Great Marlborough Street, Manchester

Summary of Proposed Amendments to Consented Scheme

November 2023

Typical Rucksack Floor Plan

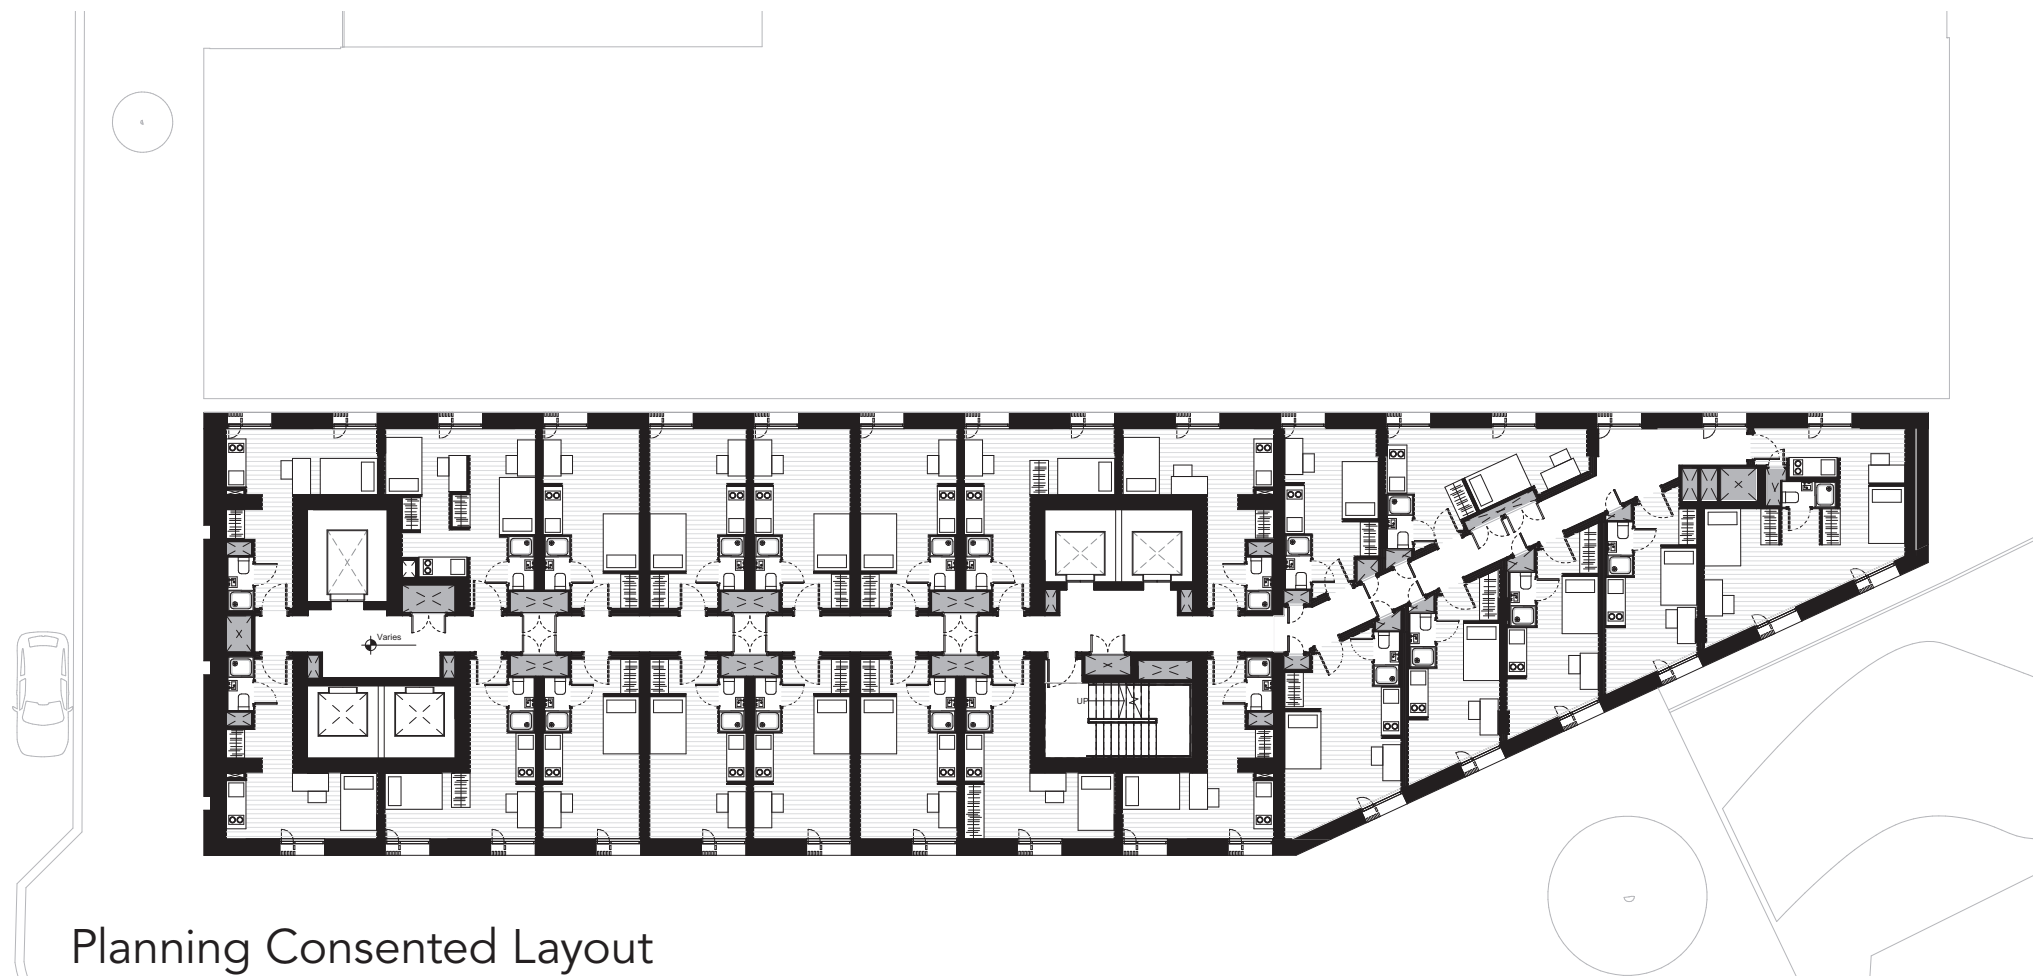
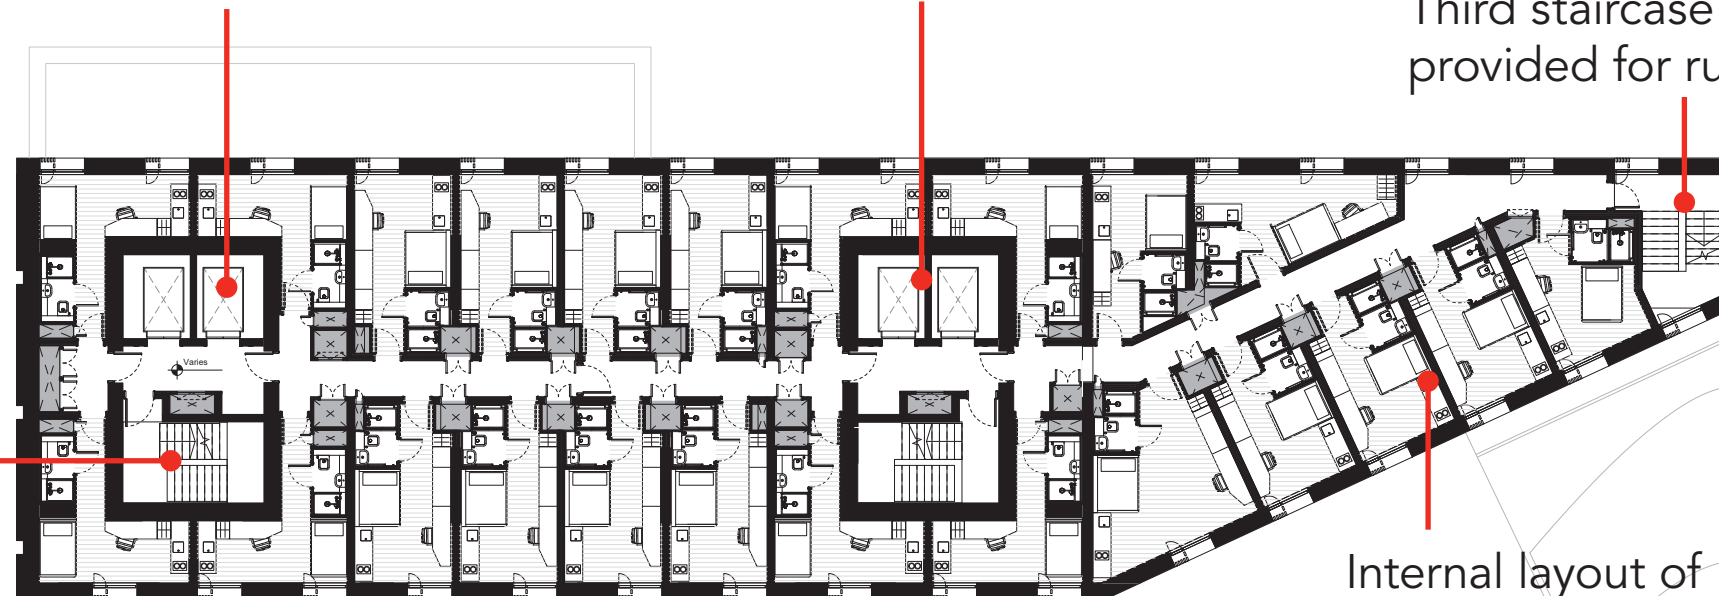
Cores, riser and room layouts refined to reflect simplified and improved vertical transportation strategy and revised fire strategy to draft BS9991

Addition of second staircase as draft Part B guidance

Third staircase provided for rucksack

Internal layout of rucksack amended to suit stair position

Typical Tower Floor Plan

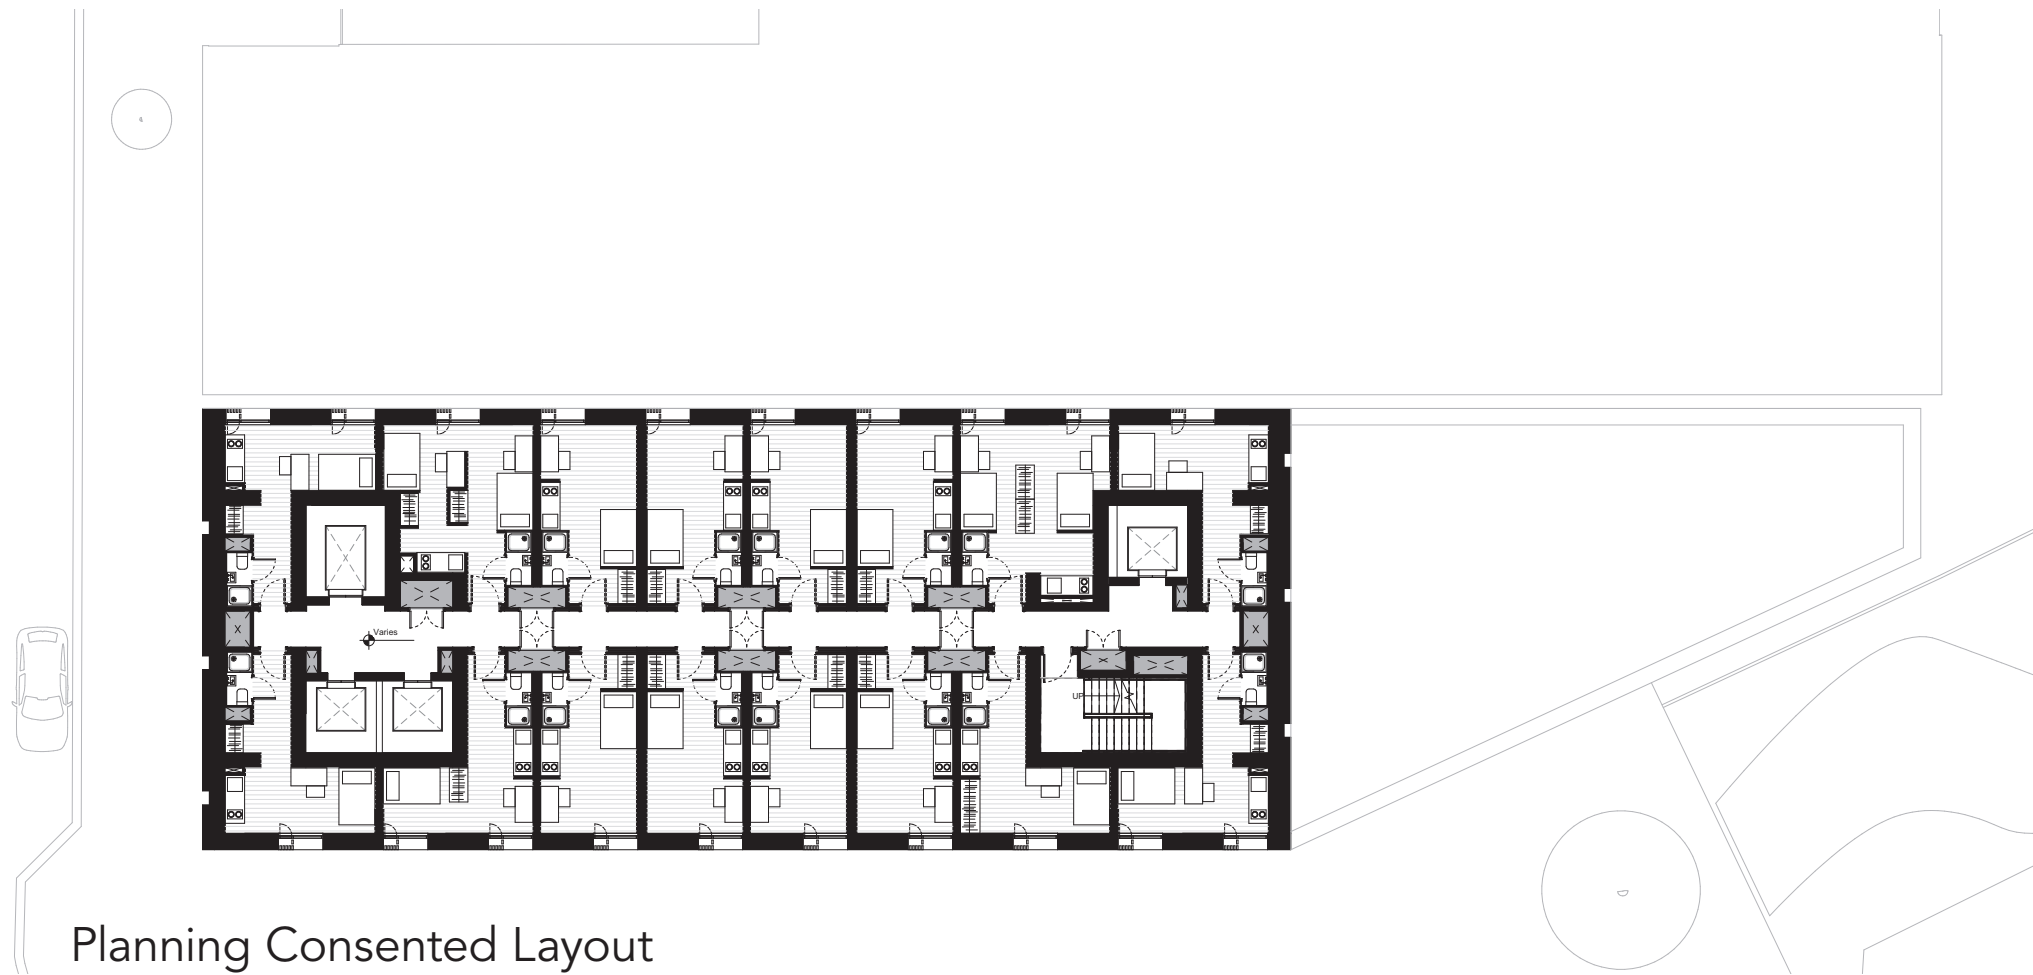
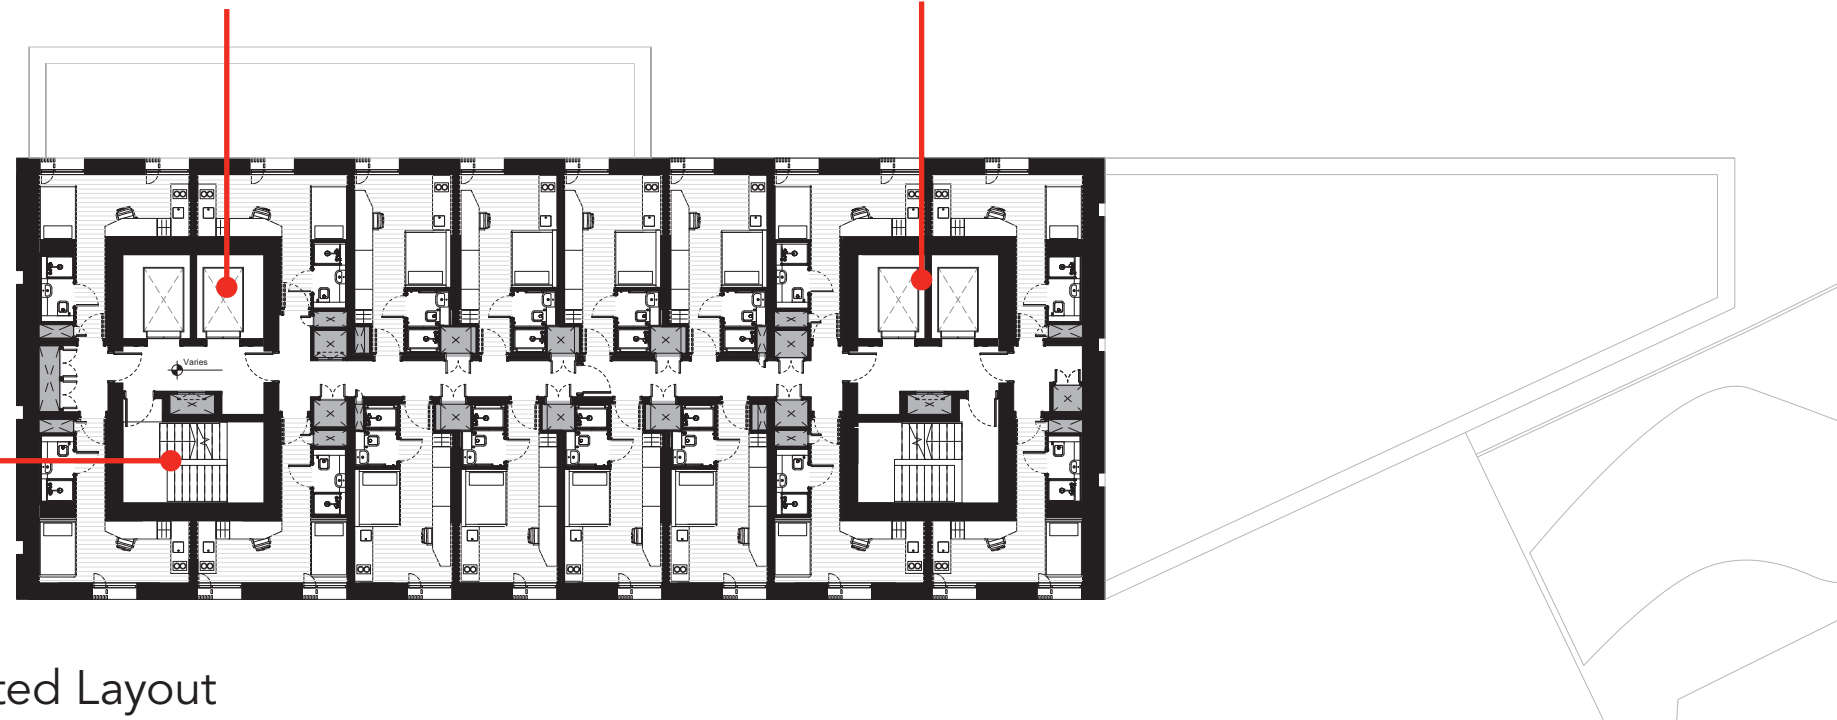
Cores, riser and room layouts refined to reflect simplified and improved vertical transportation strategy and revised fire strategy to draft BS9991

Addition of second staircase as draft Part B guidance

Adaptable Rooms

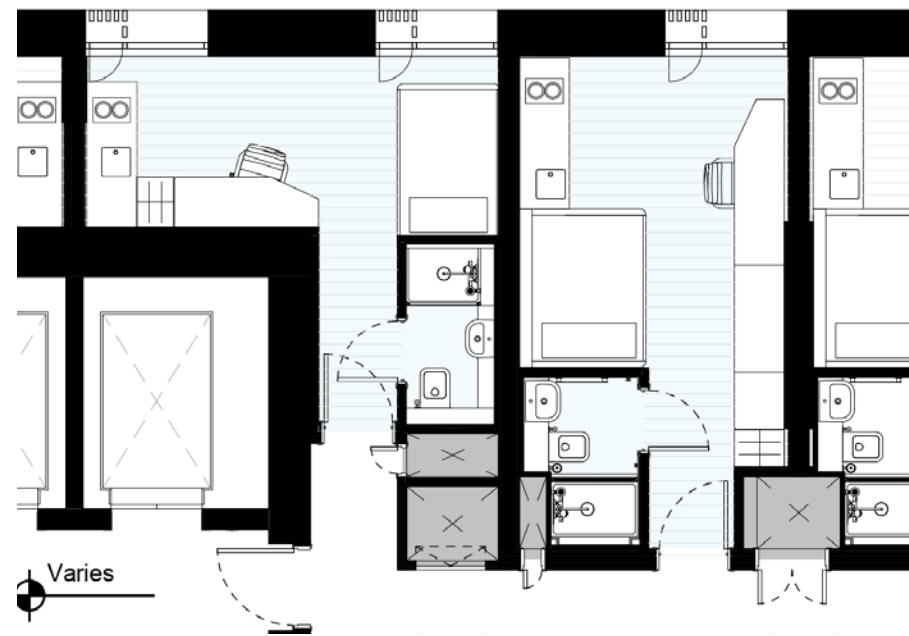
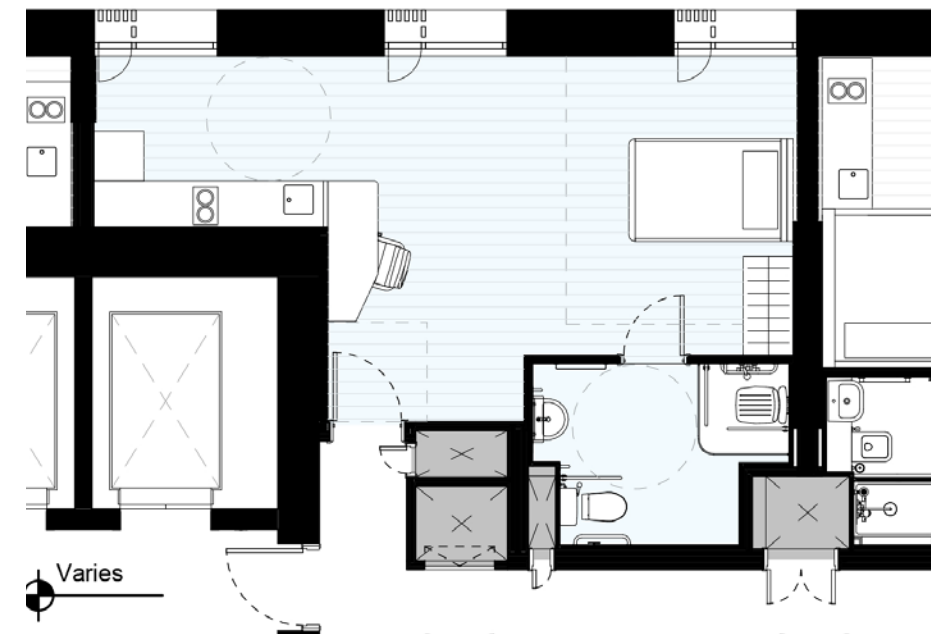
The consented scheme had a wheelchair adaptable 'twodio' at every level. The space used by this 'twodio' is now required for the provision of a full escape core, therefore it is proposed to retain this adaptability by designing for the combination of two rooms at every level in the same location. This is shown adjacent.
